Subject: Sequoyah Fuels Corporation, Docket – 40-8027  
Response to Draft Safety Evaluation Report – Reclamation Plan  
(TAC L52511)

**Sequoyah Fuels Corporation  
Draft Safety Evaluation Report (DSER)  
Response to Remaining Open Issues as of May 2006**

FIGURE 1  
STREAM 005 DETAIL

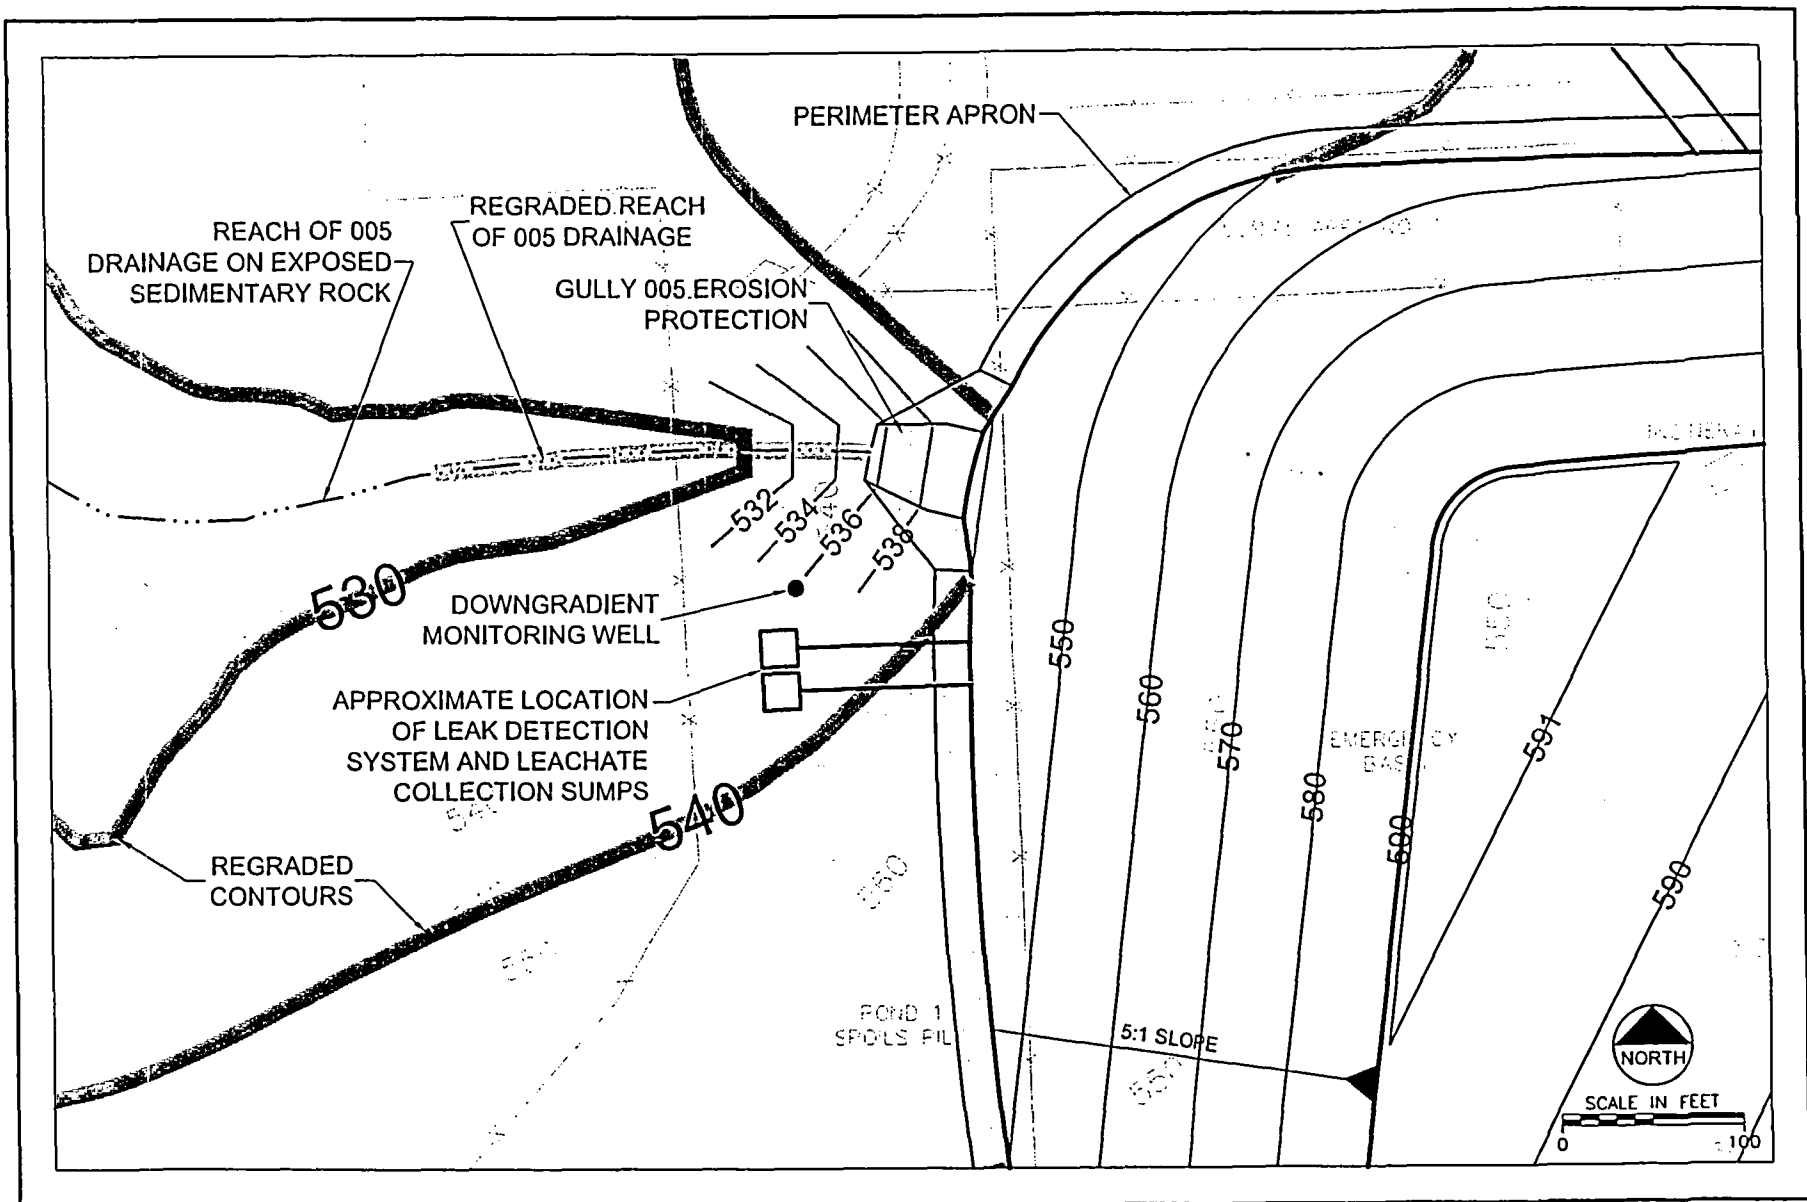
1. **DSER OI.01** The licensee needs to provide an analysis regarding the potential for Stream 005 to encroach upon the foot or apron of the proposed cell. (SER Section 2.4.2)

This open issue (OI) and OI.20 pertain to erosion of Stream 005 and its effect on the west side of the disposal cell. The geomorphology of Stream 005 is addressed under OI.01 and the details of erosion protection are addressed under OI.20.

The SFC facility is underlain by sandstones and shales of the Pennsylvanian Period Atoka Formation (described in the Reclamation Plan). The bed of Stream 005 was eroded in the sedimentary rocks to its current level prior to construction of the SFC facility, when the catchment area draining to Stream 005 was larger than it is at the present time. The contributing catchment area to Stream 005 will be reduced further after disposal cell construction.

The bed of Stream 005 west of the disposal cell has exposed sandstone and shale, in the reach shown in Figure 1. East (upgradient) of this reach of Stream 005, the bed slope is steeper due to fill placement by SFC. Disposal cell construction with erosion protection material placement (described in OI.20) will reduce the bed slope of Stream 005 in this area of fill placement, as shown in Figure 2. This has been designed to protect against gully intrusion from Stream 005 as well as provide erosion protection from runoff from the west slope of the disposal cell.

FIGURE 2  
EROSION PROTECTION FACILITIES AT TOP OF STREAM 005 DRAINAGE

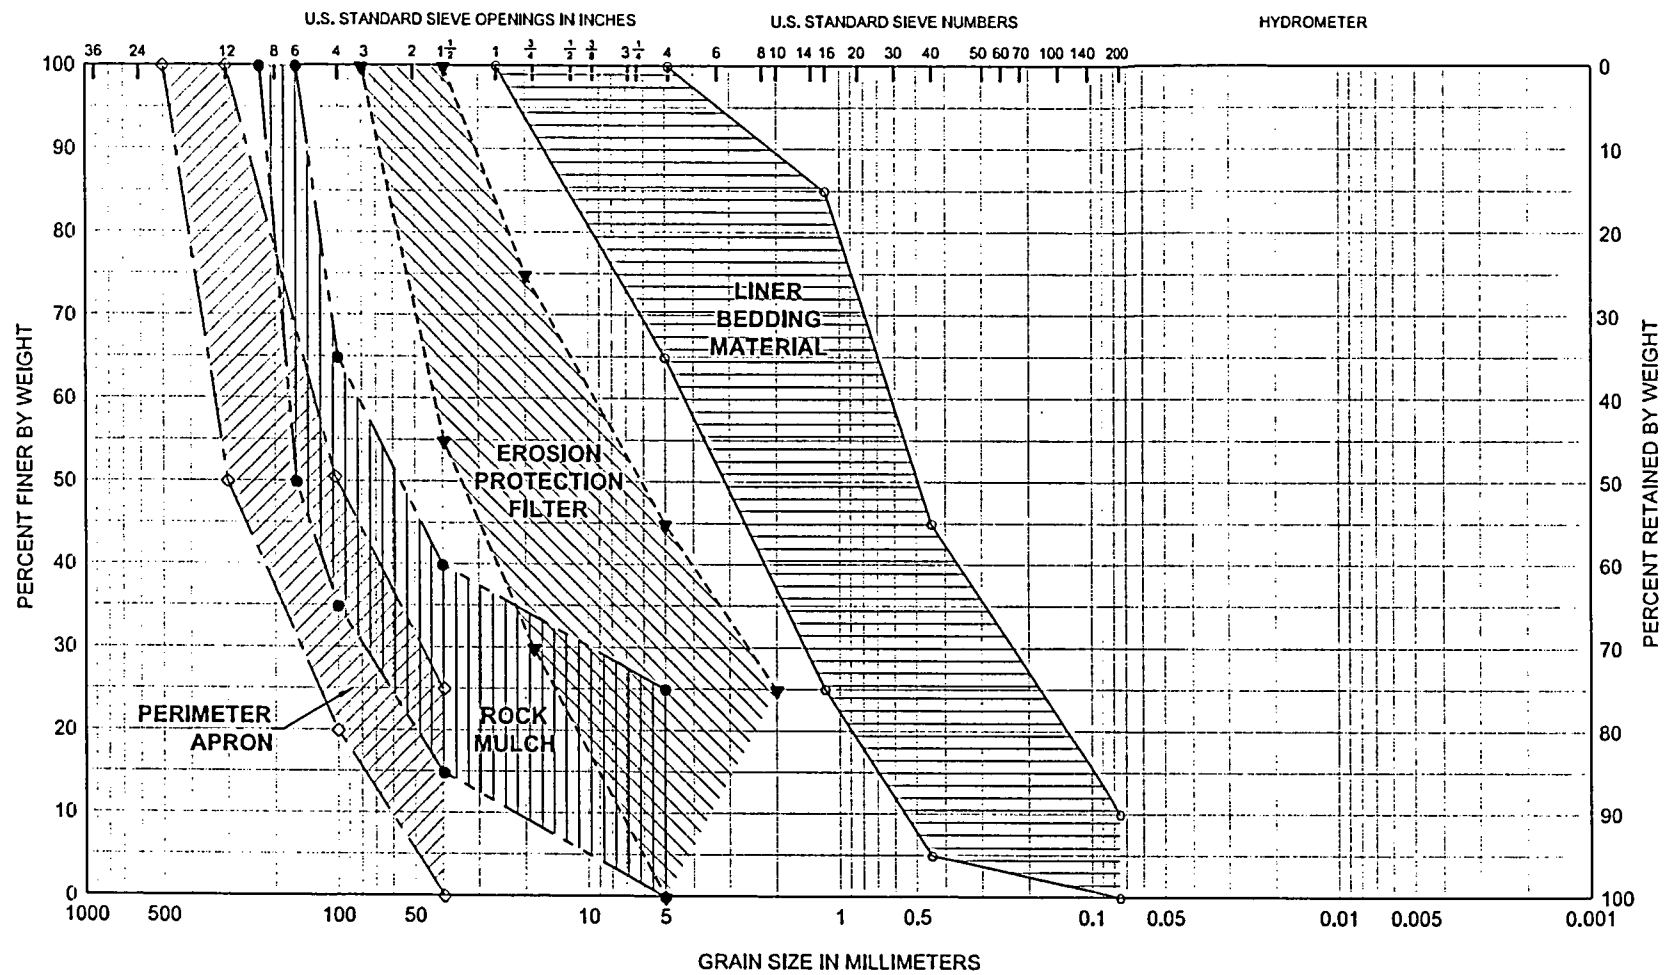
9. **DSER OI.20** The licensee needs to provide a design for rock armor protection of stream 005. (SER Section 4.5.1.3)

This feature has been provided and enlarged, based on discussions with NRC. The updated rock armor protection layout is shown in Figure 2.

A rock apron has been included in the disposal cell design to provide protection in the unlikely event of headward erosion from Stream 005. The rock apron is a downstream extension of the perimeter apron at the toe of the disposal cell slopes and is located where runoff from the west slope of the disposal cell discharges into the east end of Stream 005. The rock apron will be keyed into underlying shale and constructed with the perimeter apron rock.

**FIGURE 3**  
**PARTICLE-SIZE DISTRIBUTIONS OF EROSION PROTECTION AND**  
**BEDDING MATERIALS**

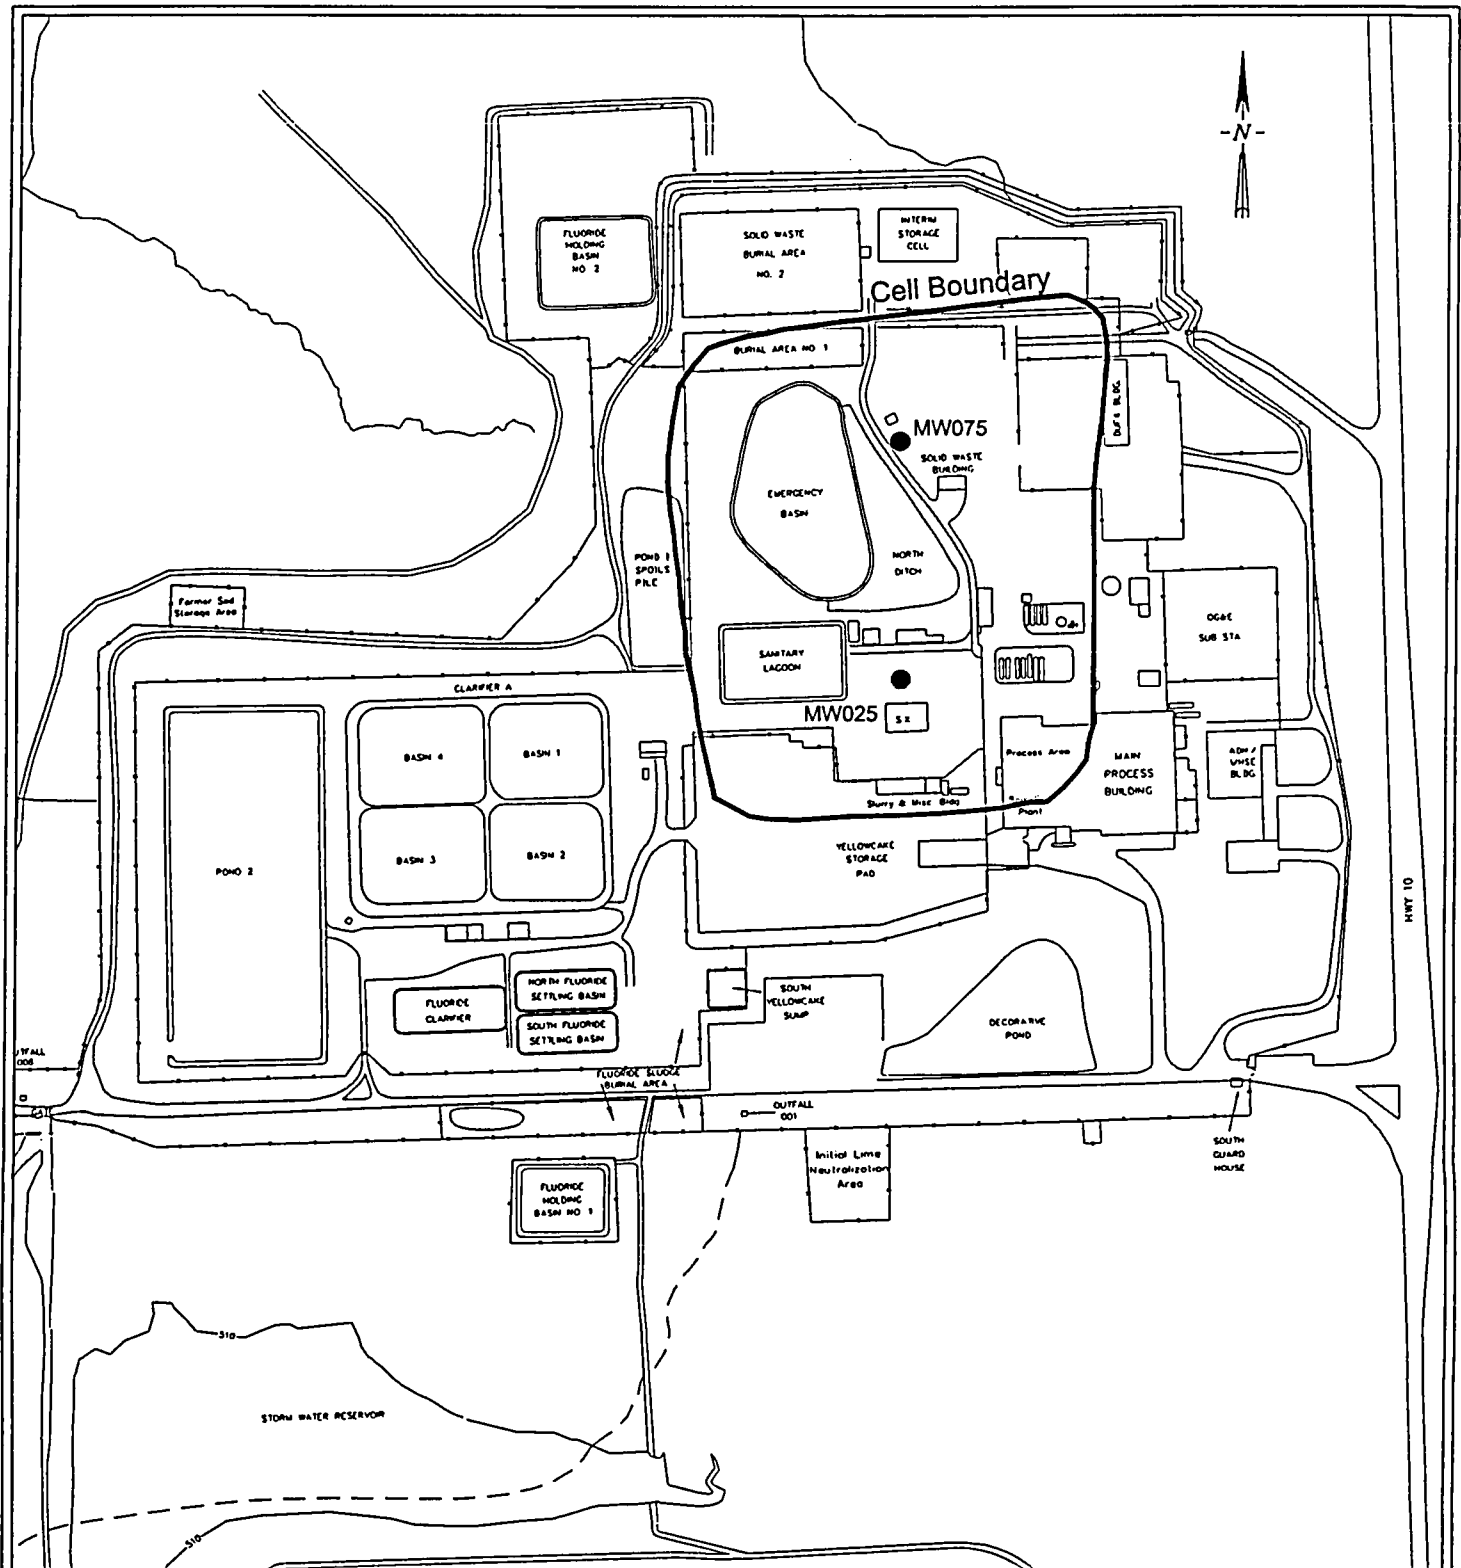
10. **DSER OI.21** The licensee needs to provide specifications for riprap rock gradation. (SER Section 4.5.2)

<u>Sieve Size</u>	<u>Percent Passing</u>
9-in	100
6-in	50-100
4-in	35-65
1.5-in	15-40
No. 4	0-25

This gradation is shown in Figure 3.

<u>Sieve Size</u>	<u>Percent Passing</u>
16-in	100
12-in	50-100
6-in	50-100
4-in	20-50
1.5-in	0-25

This gradation is shown in Figure 3.
